V2500-A1/A5/D5 PROPULSION SYSTEMS SERVICE BULLETIN

This document transmits Revision 4 to Service Bulletin V2500-ENG-72-0334 and the Initial Issue of the Supplement

V2500-ENG-72-0334

ENGINE – ACTUATING MECHANISM HP COMPRESSOR VARIABLE VANES – INTRODUCTION OF REVISED
STAGE 3 AND STAGE 4 VSV ACTUATOR RING LEVERS WITH INCREASED RADIUS

Lever positions - Stage 3 VSV mechanism - Parts 2 and 3
Figure 1

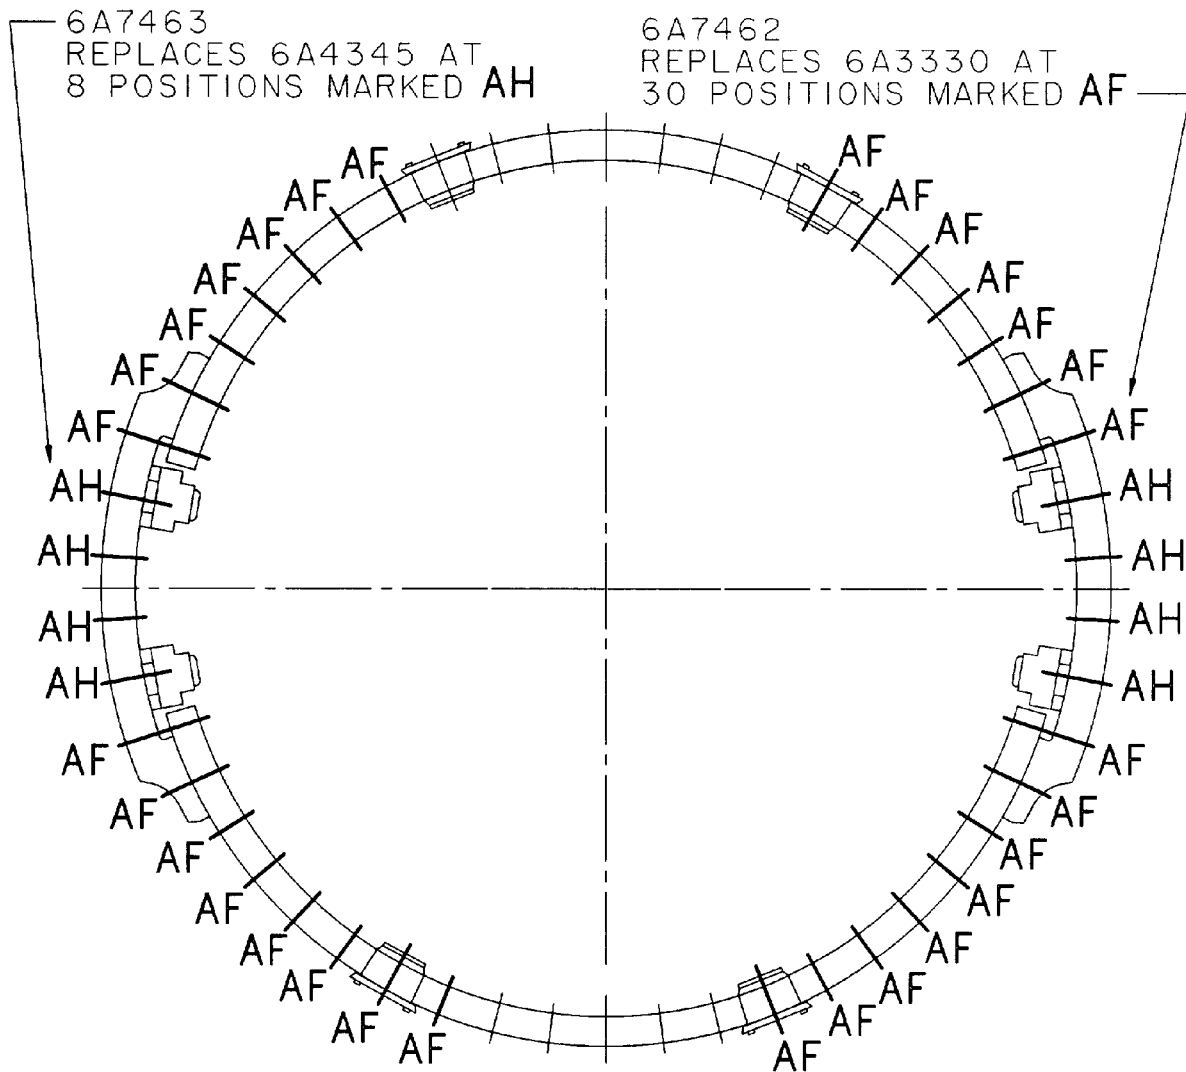
6A7460
REPLACES 6A332I
AT 16 POSITIONS MARKED AB

DIAGRAMMATIC VIEW OF
STAGE 3 VSV MECHANISM
SHOWING LEVER POSITIONS

Lever positions - Stage 4 VSV mechanism - View to the rear - Part 3
Figure 2

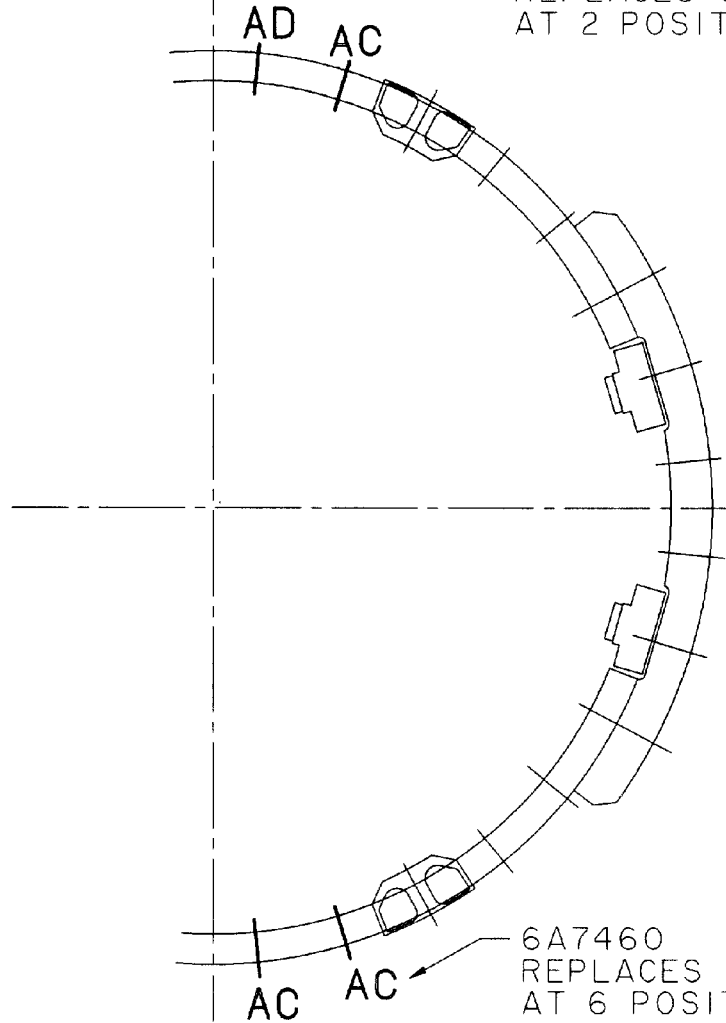
6A7461
REPLACES 6A3323
AT 2 POSITIONS MARKED AD

6A7460
REPLACES 6A3321
AT 6 POSITIONS MARKED AC

Example of mis-located dowels
Figure 5

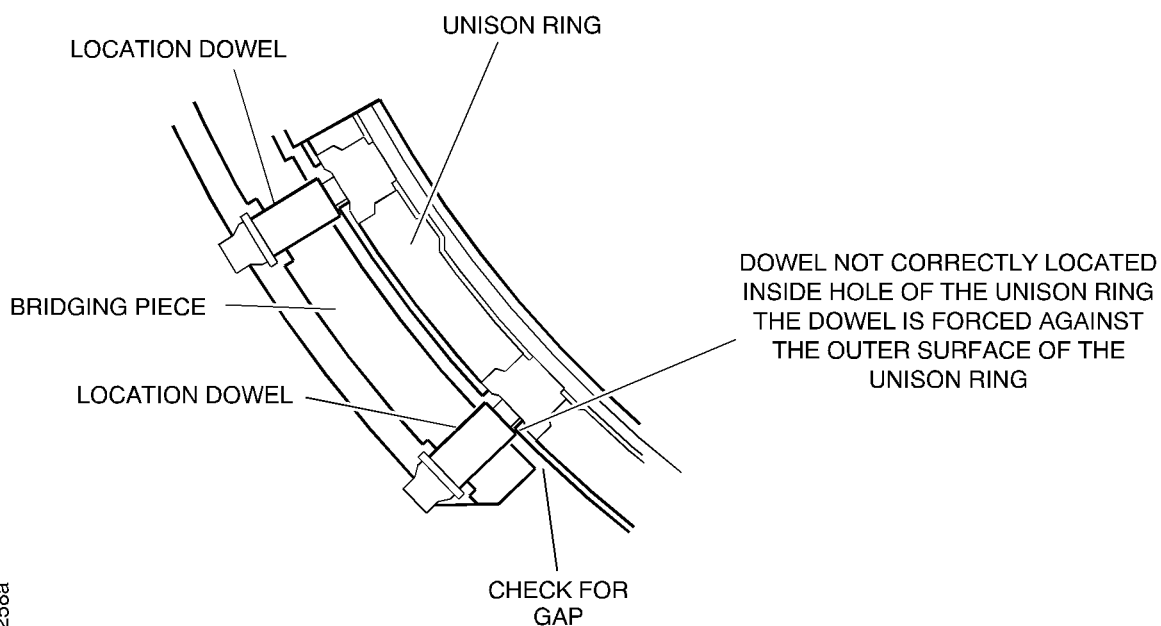
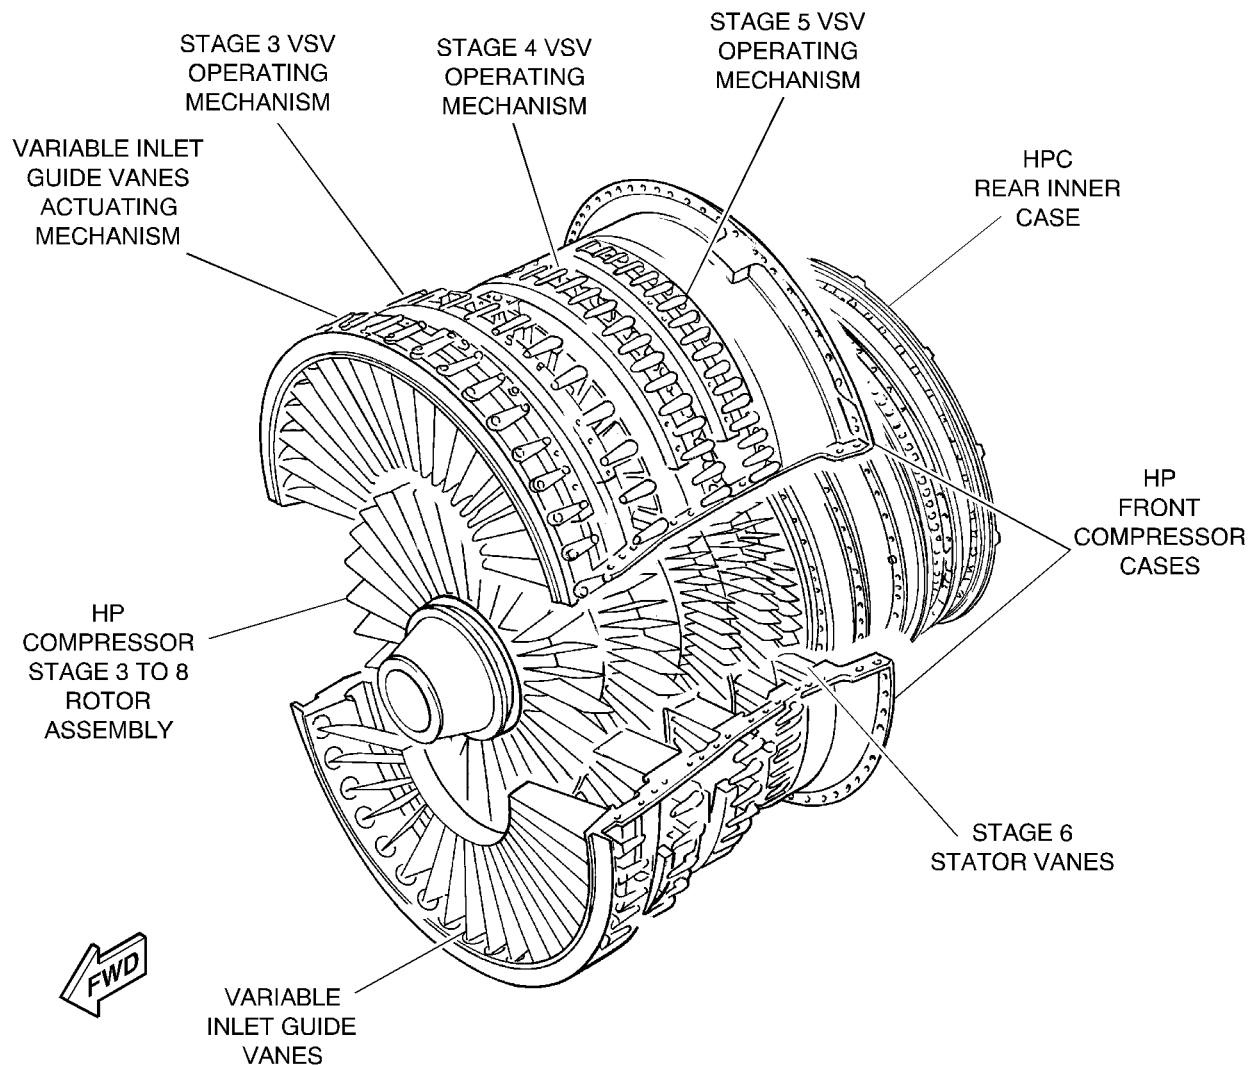
NOTE: Make sure that the bridge piece location dowels are seated correctly in the unison ring (see Figure 5).

- (iii) Install the four bolts (AS21020) and the bolt (AS21014) that safety the bridge piece. Make sure the dowels are correctly located into the unison ring.
- (iv) Torque load the bolts to between 85 and 105 lbf in. (10,00 and 12,00 Nm).
- (v) Make sure the bridge piece is seated tightly against the unison ring; use a feeler gauge between 0.002 and 0.004 in. and check for gaps between the mating surfaces of the bridge piece and the unison ring. There should not be any gap between the mating surfaces (see Figure 5).
